POWER STEERING CYLINDER UPDATE

Figure A

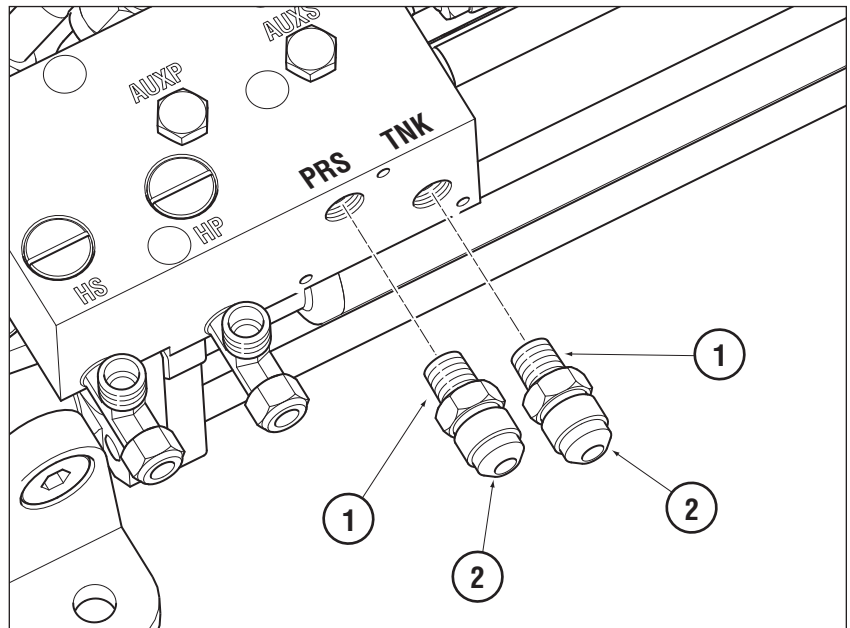
Teleflex Marine would like to advise our customers of a change to ALL SeaStar Power Steering Cylinders. In the past, the hose fittings on the steering cylinder servo valve marked with PRS and TNK have been pre-installed. These fittings will no longer be pre-installed at the factory and will come packaged in a separate bag with the cylinder. This change is being implemented to assist with the installation of the new DC Power System.

1. Apply a liquid, Teflon based pipe sealant to the threads of the fitting going into the Servo Valve Block. **DO NOT USE TEFLON TAPE.**
2. Install fitting into port and torque to 19 ft.lb. (25.76Nm).
